INVITATION FOR BIDS

CCK-2516-21 ADDENDUM # 4 01/13/2021

UK 5th Floor Paitent Room Fit Out ADDENDUM No. 4 CCK-2516-21 01/12/2021

A500 SCALE: 1/8" = 1'-0"

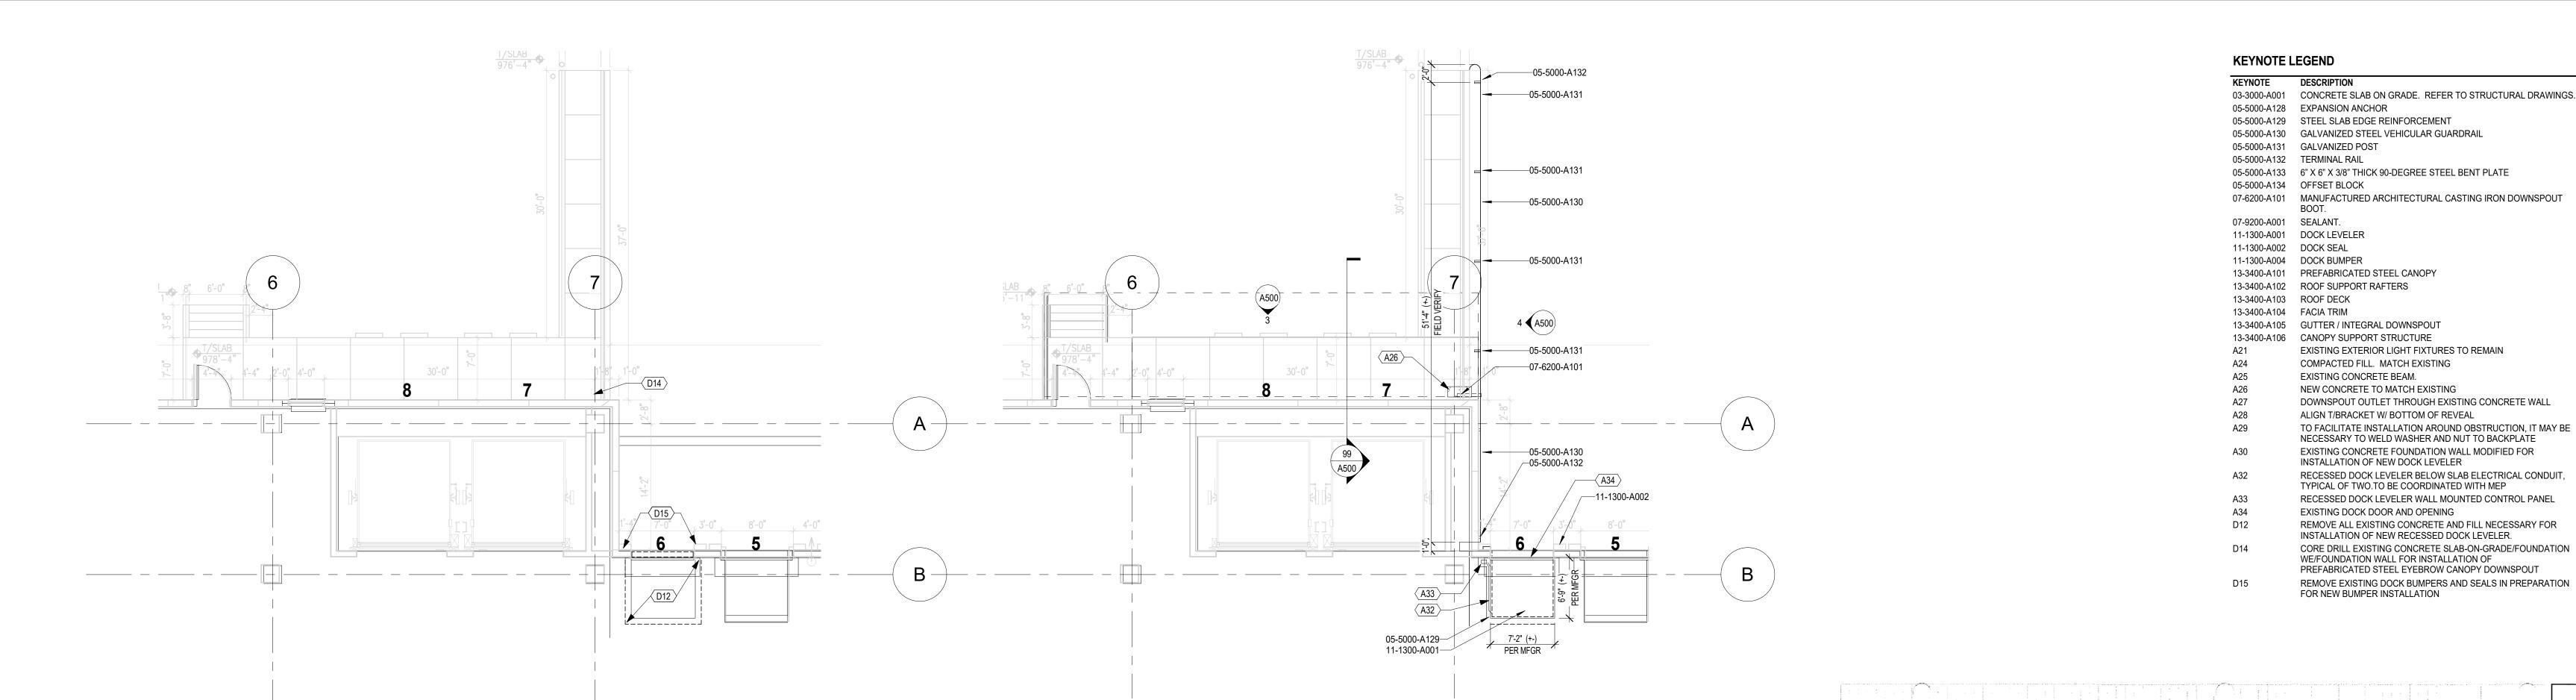
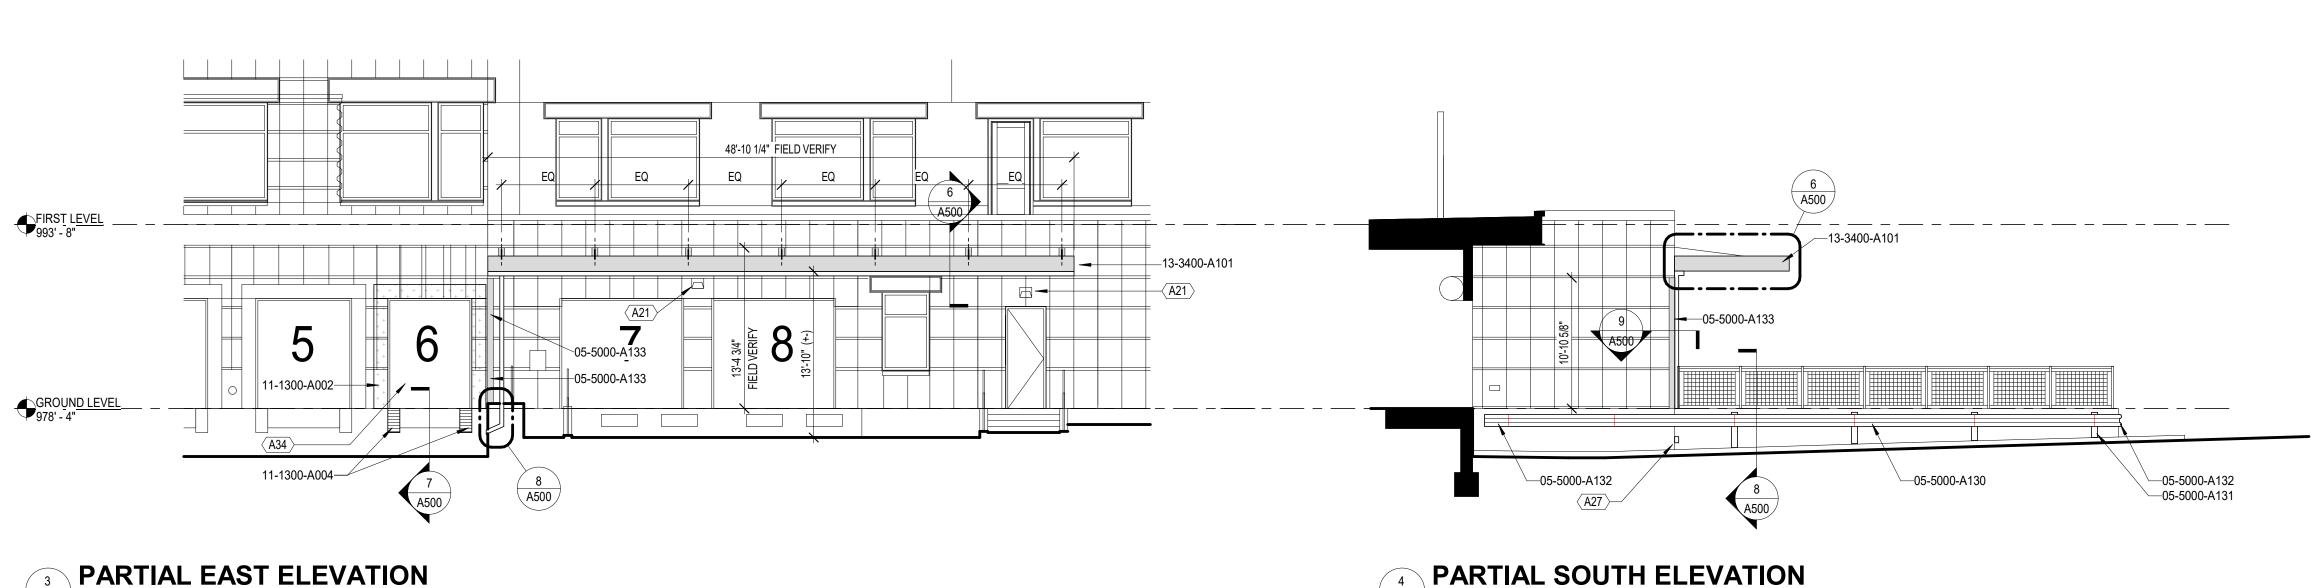
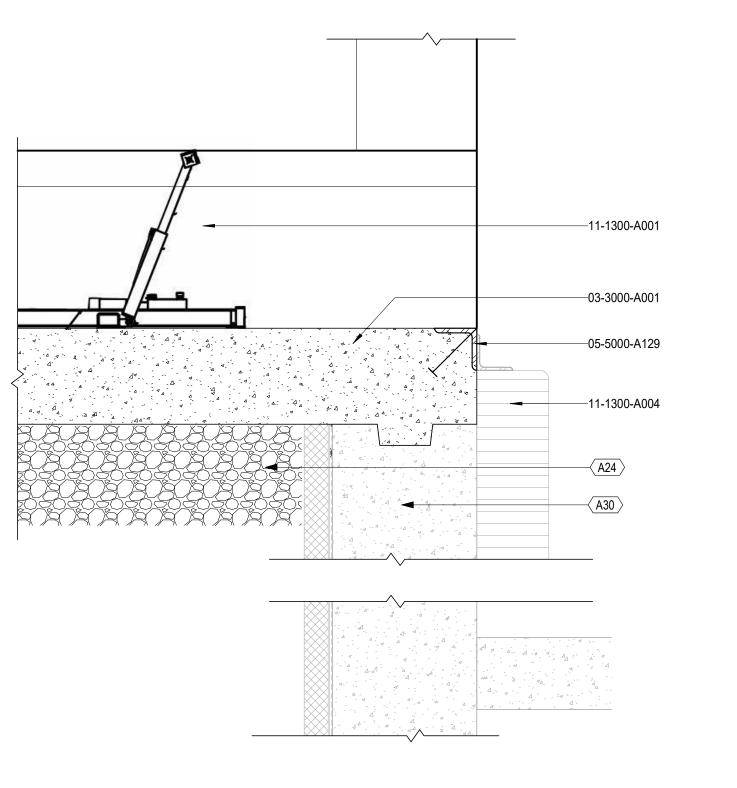
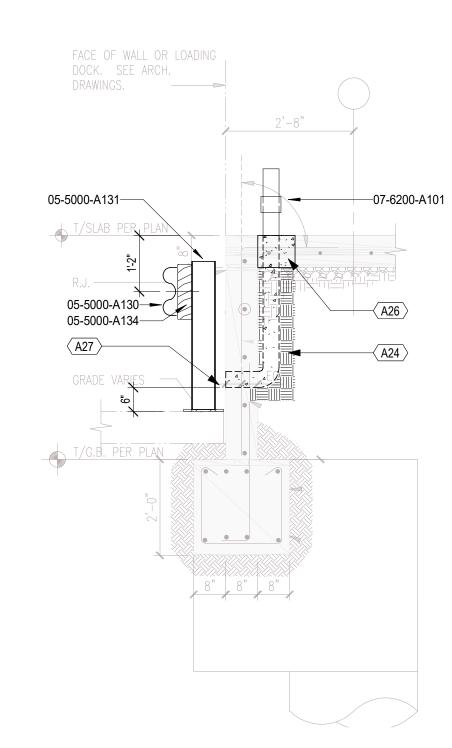
- 2.1 Sheet A500
 - A. Sheet issued to define loading dock canopy and dock leveler scope.
- 2.2 Sheet A611
 - A. Sheet re-issued. See revisions indicated ADDM-4
- 2.3 Sheet V-1.1
 - A. Sheet re-issued to address clarity of the vendor drawing.
- 2.4 Sheet V-11.1
 - A. Sheet issued to define window replacement scope.
- 2.5 Sheet i330
 - A. Detail 9/i330: Delete single end wall guard and provide (2) CG-1.
- 2.6 Sheet P901
 - A. MG-5-1 ICU gas outlet quantities updated.
- 2.7 Sheet E105A, E105B, E105C
 - A. Revised keynotes 2 and 5.
- 2.8 Sheet E105D, E205A, E205B, E205D
 - A. Revised keynote 2.
- 2.9 Sheet E303D
 - A. Extended view to include existing equipment.

**LEVEL 05 SECURITY** FLOOR PLAN - AREA A

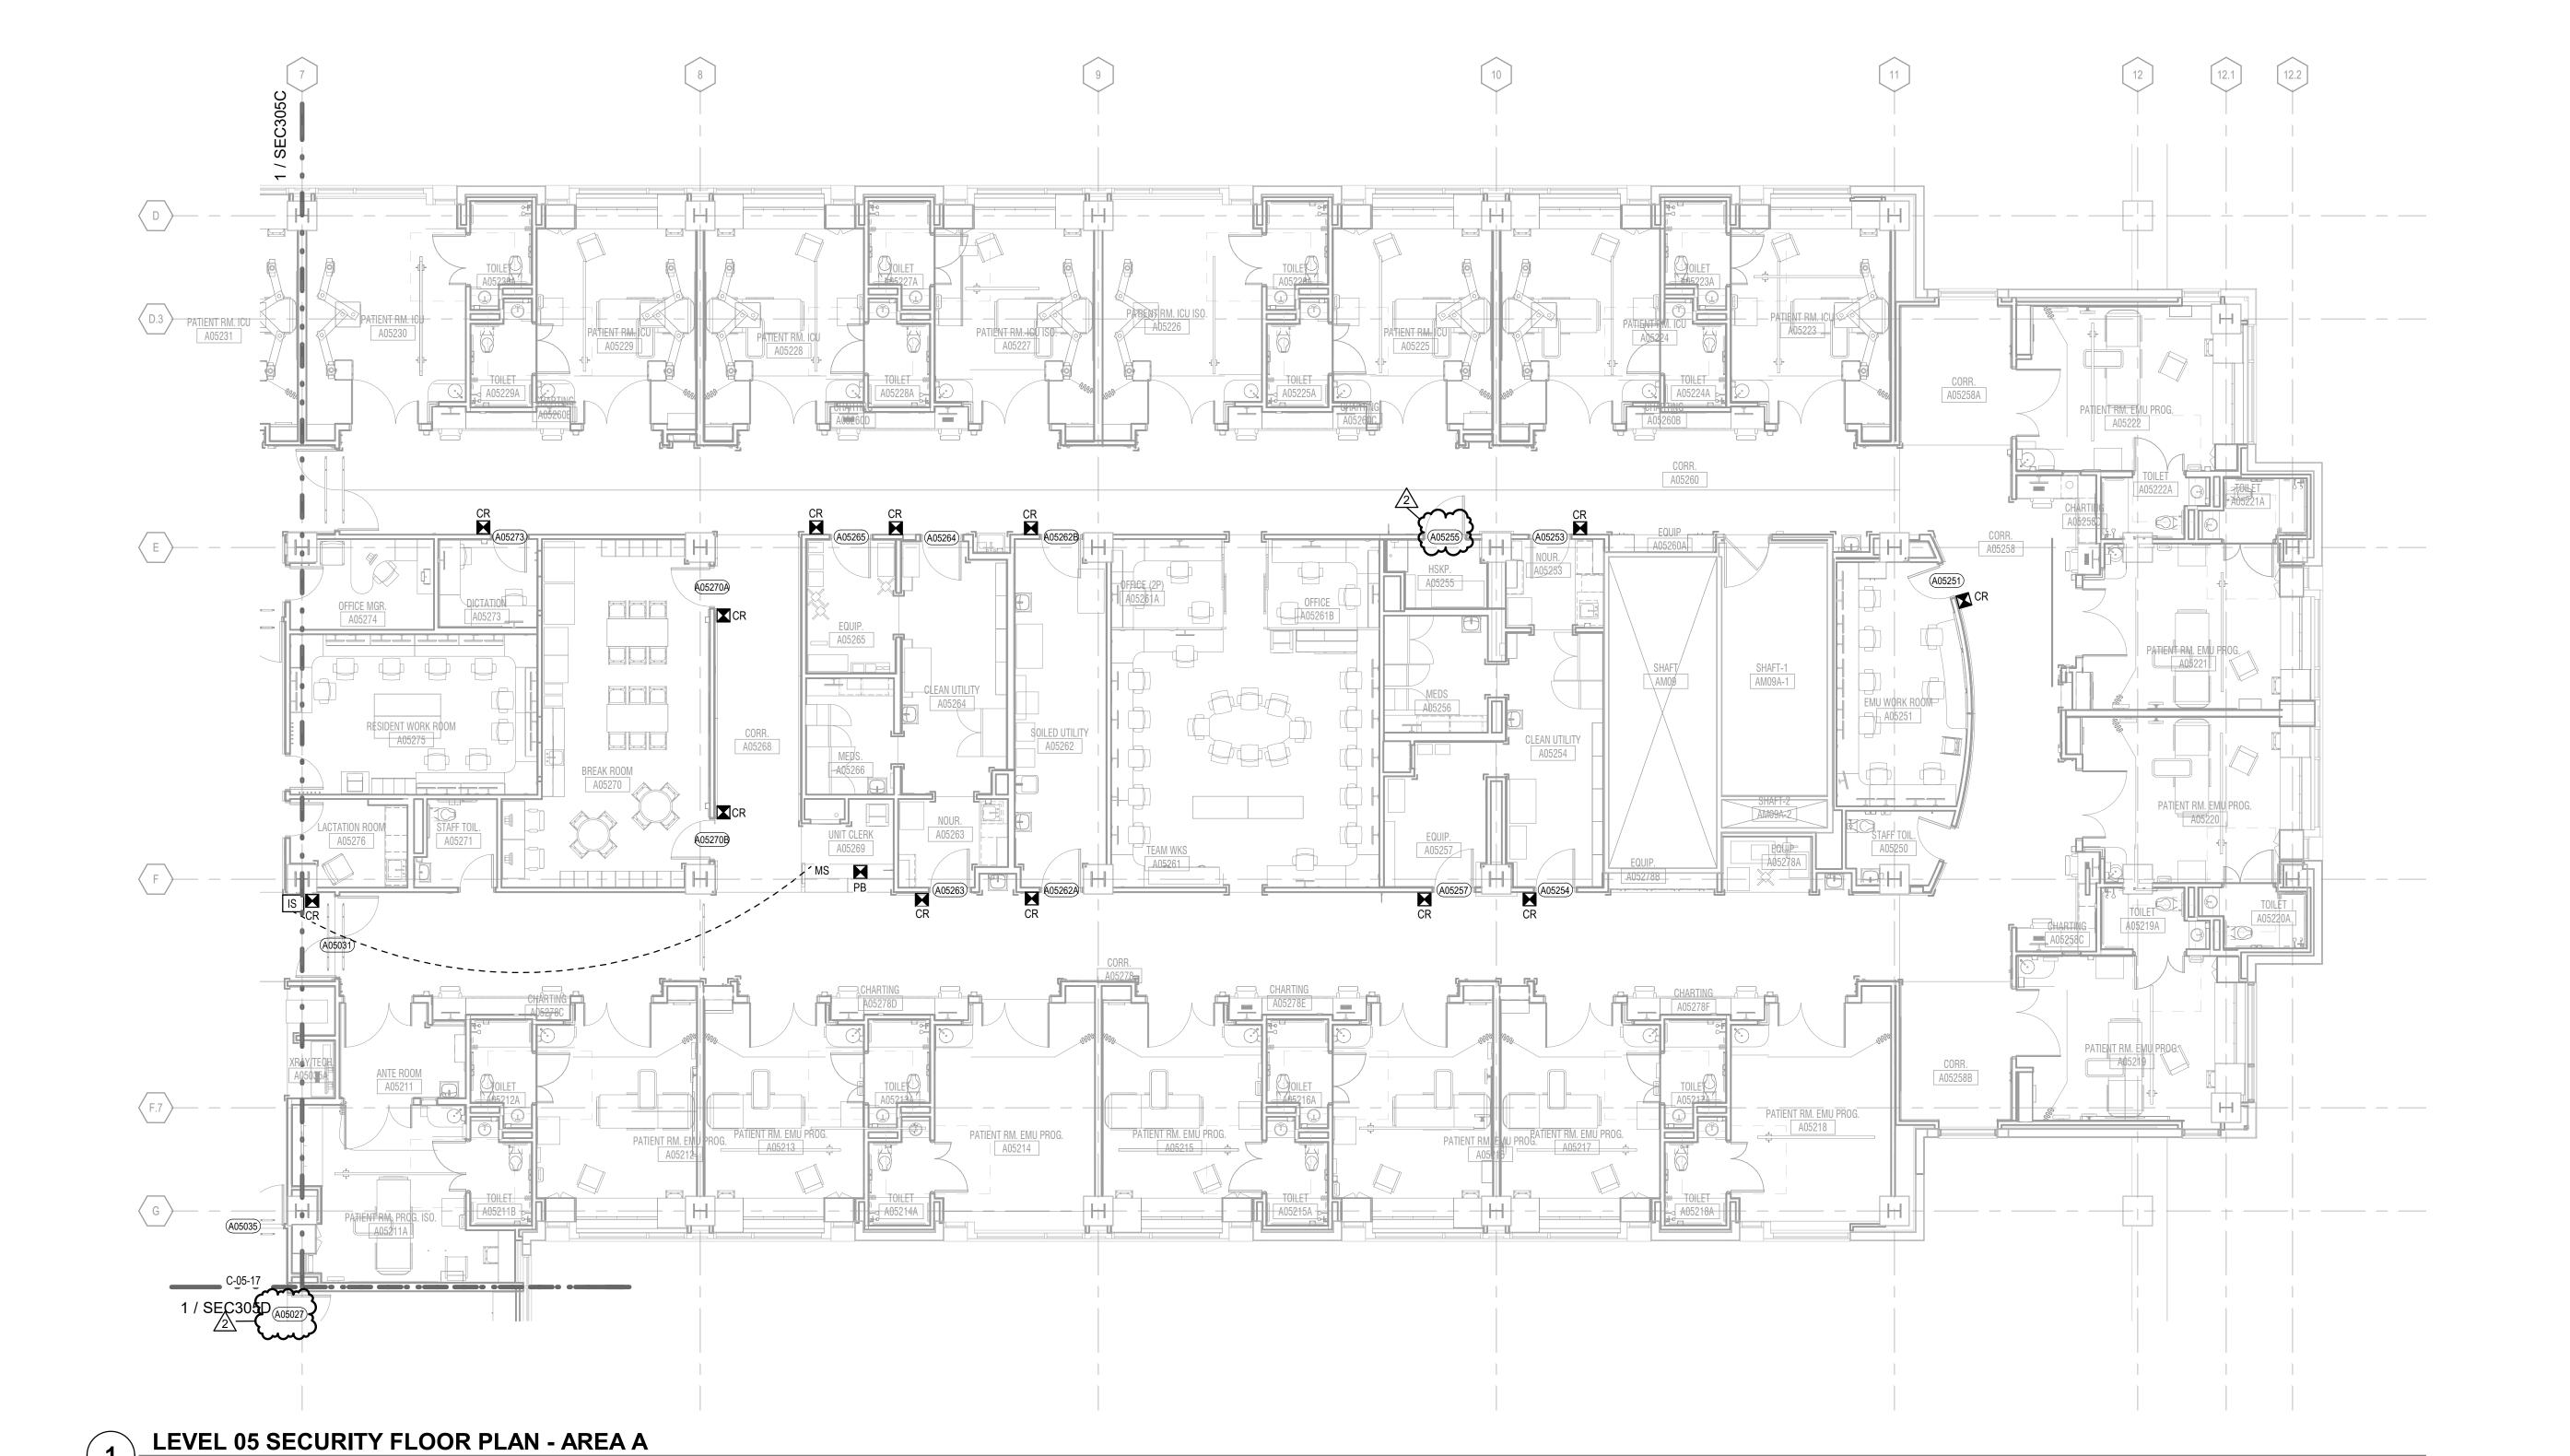
1 REFER TO SHEET SEC305D FOR CONTINUATION.
